Alignment Marker Format Updates

Adrian Butter (on behalf of the P802.3bs Logic Ad Hoc team)

D1.2 Comments Regarding Alignment Markers

CI 119 SC 119.2.4.5 P 100 L 32 # 2
Butter, Adrian GLOBALFOUNDRIES

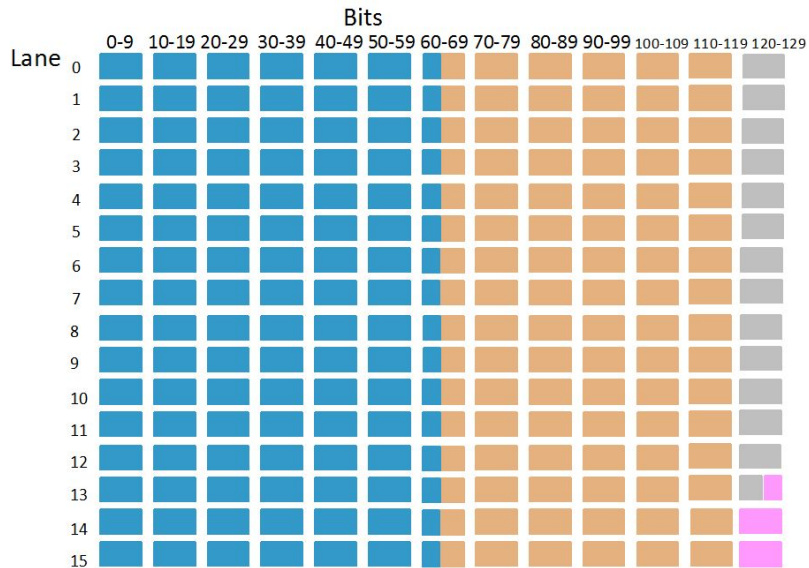
There is no clear connection between variables tx_scrambled_am and tx_scrambled_am_j. Also, defining tx_scrambled_am as 257 bits does not align with the width implied in 119.2.4.4, page 97, line 25.

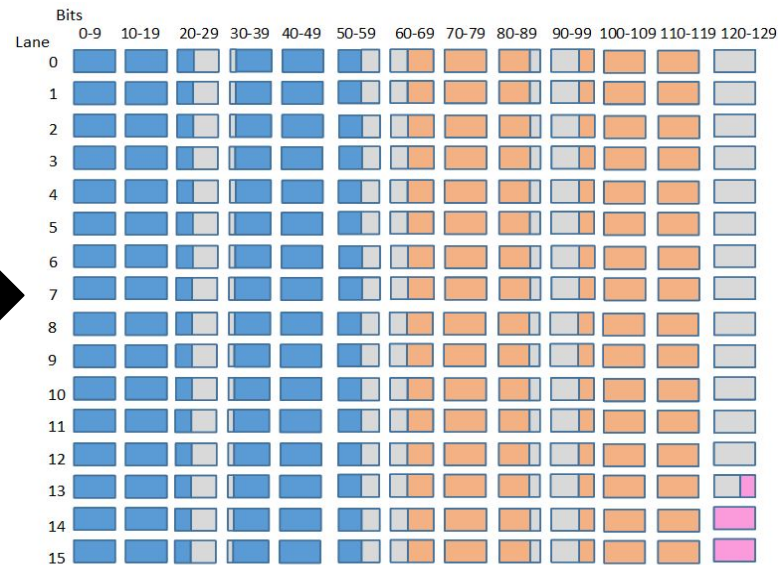
Change alignment marker format from:

- Common marker (64 bits)
- Unique marker (56 bits)
- Pad (136 bits)
- Next 257-bit block

... to:

- Common marker (48 bits)
- Unique marker (48 bits)
- Pad (520 bits)
- Next 257-bit block

119.2.4.4 Alignment marker mapping and insertion

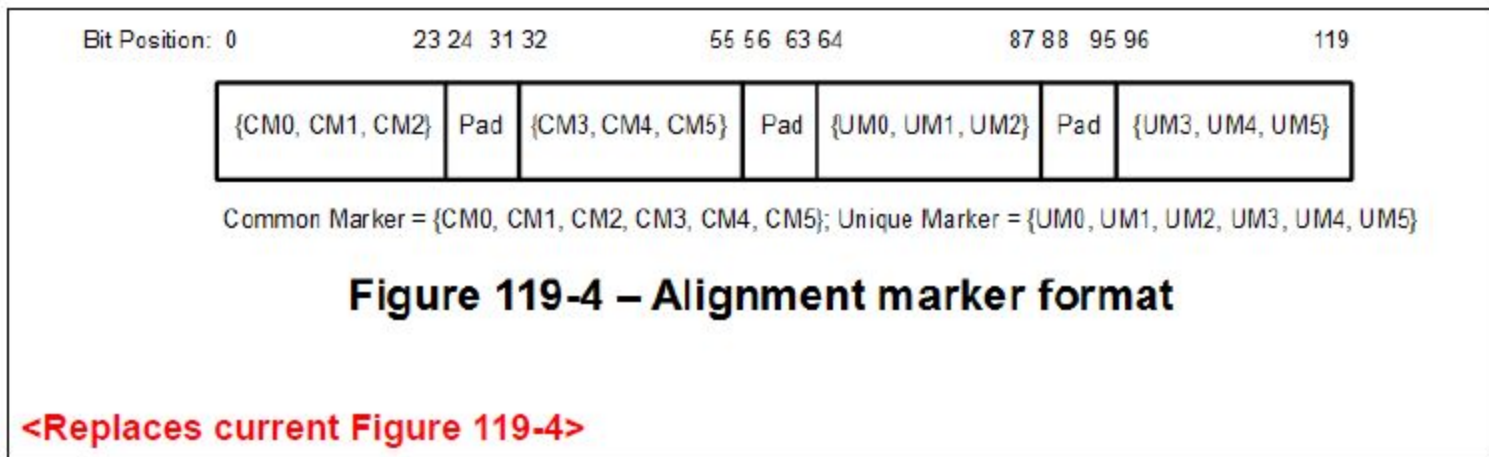
In order to support deskew and reordering of the 16 individual PCS lanes at the receive PCS, alignment markers are added periodically for each PCS lane. The alignment marker for each PCS lane is a ~~unique 120~~ fixed 96-bit block. The alignment markers for all PCS lanes are inserted as a group, aligned to the beginning of ~~a two~~ FEC blocks, and interrupt any data transfer that is already in progress. The 96-bit alignment marker for each PCS lane is interleaved with 24 pad bits to achieve alignment marker field positioning which mimics that defined in 91.5.2.6. An additional 136-bit pad is appended to the alignment markers to yield the equivalent of eight 257-bit blocks. The pad bits shall be set to a free running PRBS9 pattern, defined by the polynomial $x^9 + x^5 + 1$, which advances by 520 bits between alignment marker mapping and insertion sequences. The initial value of the PRBS9 pattern generator may be any pattern other than all zeros. The pad shall not be checked on receive.

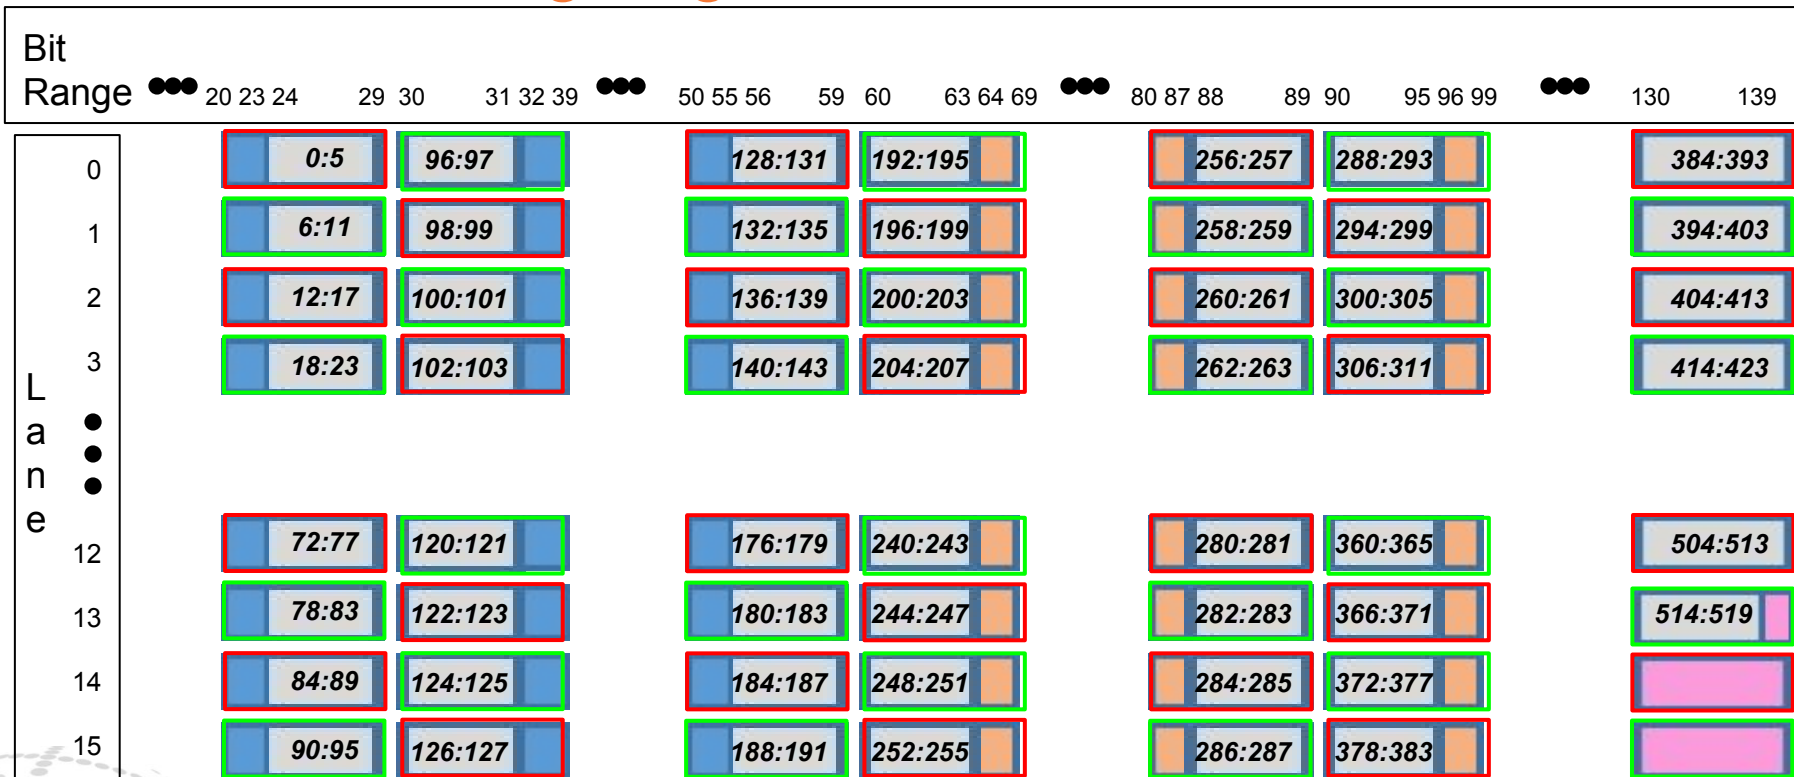
The alignment marker mapping function operates on a group of 16 alignment markers. Let $am_x\langle 119:0 \rangle$ be the alignment marker for PCS lane x , $x=0$ to 15, where bit 0 is the first bit transmitted. The alignment markers shall be mapped to $am_mapped\langle 1919:0 \rangle$ in a manner that yields the same result as the following process.

a) $am_x\langle 23:0 \rangle$ is set to CM_0 , CM_1 , and CM_2 , as shown in Figure 119-4 (bits 23:0) using the values in Table 119-1 for PCS lane number x .

b) $am_x\langle 31:24 \rangle = \{PRBS9\langle 2*x+97:2*x+96 \rangle, PRBS9\langle 6*x+5:6*x \rangle\}$, as shown in Figure 119-4 (bits 31:24) is an 8-bit pad value of PRBS9 pattern bits, where bit $6*x$ is the first PRBS9 bit output of the 8-bit pad.

c) $am_x\langle 55:32 \rangle$ is set to CM_3 , CM_4 , and CM_5 , as shown in Figure 119-4 (bits 55:32) using the values in Table 119-1 for PCS lane number x .

d) $am_x\langle 63:56 \rangle = \{PRBS9\langle 4*x+195:4*x+192 \rangle, PRBS9\langle 4*x+131:4*x+128 \rangle\}$, as shown in Figure 119-4 (bits 63:56) is an 8-bit pad value of PRBS9 pattern bits, where bit $4*x+128$ is the first PRBS9 bit output of the 8-bit pad.

e) $am_x\langle 87:64 \rangle$ is set to UM_0 , UM_1 , and UM_2 , as shown in Figure 119-4 (bits 87:64) using the values in Table 119-1 for PCS lane number x .

f) $am_x\langle 95:88 \rangle = \{PRBS9\langle 6*x+293:6*x+288 \rangle, PRBS9\langle 2*x+257:2*x+256 \rangle\}$, as shown in Figure 119-4 (bits 95:88) is an 8-bit pad value of PRBS9 pattern bits, where bit $2*x+256$ is the first PRBS9 bit output of the 8-bit pad.

g) $am_x\langle 119:96 \rangle$ is set to UM_3 , UM_4 , and UM_5 , as shown in Figure 119-4 (bits 119:96) using the values in Table 119-1 for PCS lane number x .
